Project	IEEE 802.16 Broadband Wireless Access Working Group < http://ieee802.org/16 >	
Title	Summary of responses for IP-OFDMA evaluation questions/comments	
Date Submitted	2007-05-10	
Source(s)	Apostolos Papathanassiou, Shailender Timiri, Puthenkulam, Intel Corporation	Jose apostolos.papathanssiou@intel.com , shailender.b.timiri@intel.com , jose.p.puthenkulam@intel.com
Re:	IP-OFDMA Evaluation Group Comments	
Abstract	Summary of Comments and Responses	
Purpose	For Information	
Notice	This document has been prepared to assist IEEE 802.16. It is offered as a basis for discussion and is not binding on the contributing individual(s) or organization(s). The material in this document is subject to change in form and content after further study. The contributor(s) reserve(s) the right to add, amend or withdraw material contained herein.	
Release	The contributor grants a free, irrevocable license to the IEEE to incorporate material contained in this contribution, and any modifications thereof, in the creation of an IEEE Standards publication; to copyright in the IEEE's name any IEEE Standards publication even though it may include portions of this contribution; and at the IEEE's sole discr

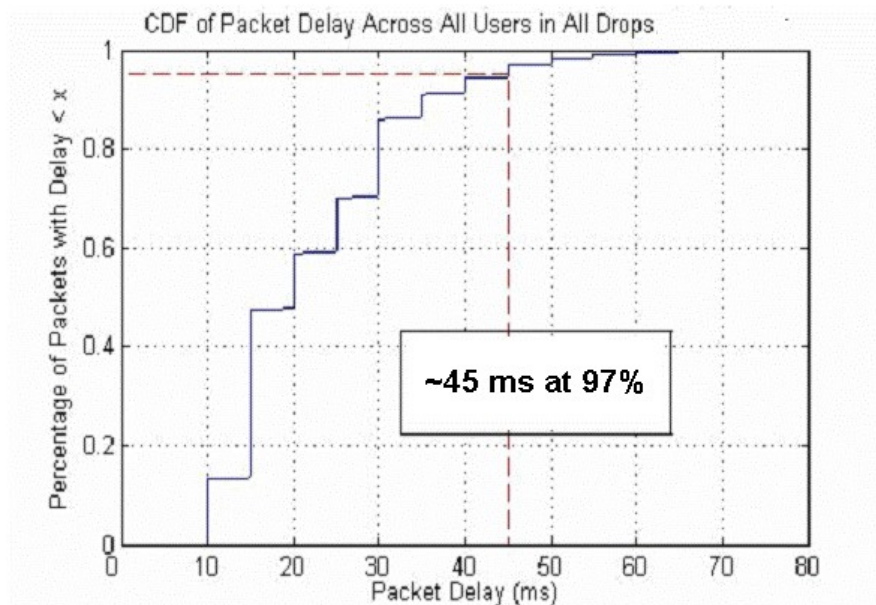
Q: Results are given with a model using Vehicular path loss and Pedestrian B3 channel model which is mixing environment information. What should be used along with the Ped B3 channel is the corresponding ITU pedestrian path loss model and alternatively a vehicular channel model should be used with the ITU vehicular path loss model. Results are to be given for each test environment indicated on the cover sheet (Indoor, Outdoor to Indoor Pedestrian, Vehicular). Furthermore, the deployment models in Annex 2 of M.1225 are to be used. The results are to be supplied using 1% blocking and 50% Voice Activity Detection, however, the submission used 2% blocking and 40% VAD (page 54, section 2.3.1.3).

A: The results in the proposal are based on widely-accepted industry channel/propagation model combinations that are currently

more popular than the original ITU M1225 combinations. Please note the additional simulation results in Appendix 1 of this document that fully comply with the pathloss model/ITU channel combinations. With respect to the comment on the voice simulation assumptions, please see the response to a related question also within the comments in A3.1.1.1.

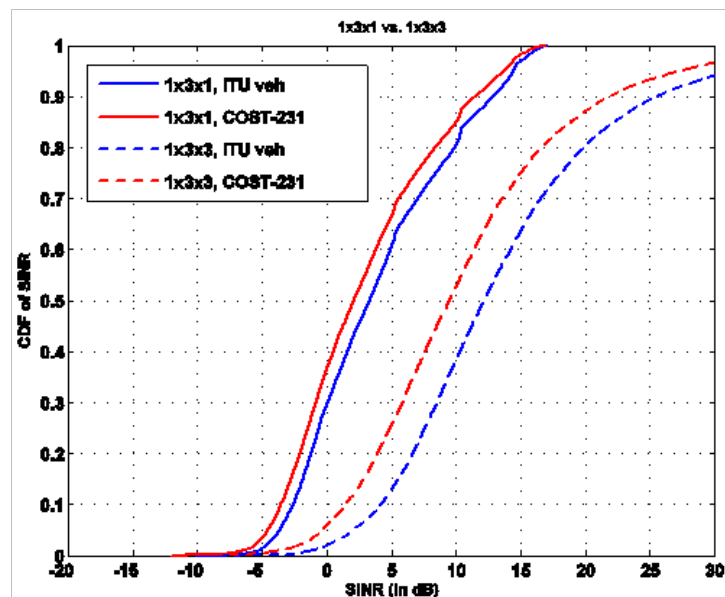
Q: Clarify which codec is used since 4 options are listed. Explain why is 40% voice activity used instead of 50% as required by M1225?

A: The codec used in the simulations is the G.729 with 20 bytes of voice payload generated every 20msec. All users are assumed to have the same codec (G.729). The voice activity factor (VAF) was chosen to be equal to 40% as that seemed to be the more widely-used value. With VAF of 50% the capacity will be somewhat reduced because it will be partly offset by the reduced overheads in each frame.

A3.2.3:

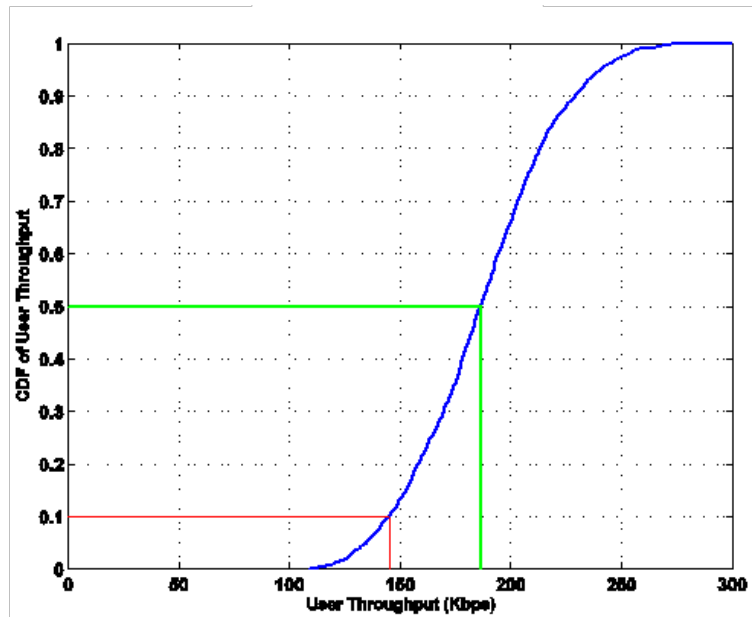
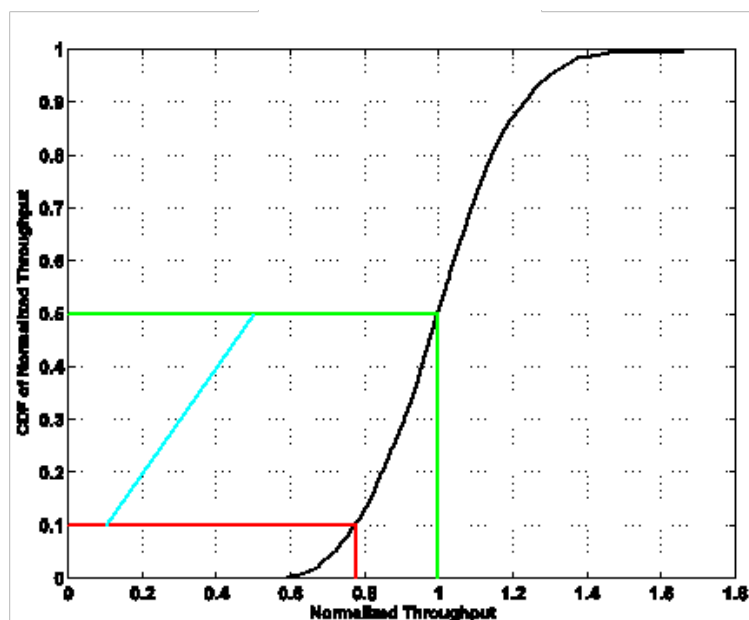
Q: What needs to be stated here also is that the UL power control is message based and each message is 44 bits. What needs to be evaluated here is that how many users in a fully loaded cell can be power controlled at the full PC rate or equivalently, what is the maximum PC rate that can be used for a fully loaded cell/sector, and whether that will be sufficient to provide the expected performance.

A: As stated in A1.2.22.2, 200 Hz is the max possible power control rate and typically is much less than 200Hz, around 10-20 Hz. At 20 Hz, the approximately 1 kbps overhead, please see the response to a related question in A1.2.7, amounts to less than 1% of the average user throughput in a SIMO deployment, i.e., the impact of the power control overhead on the system capacity is very low.
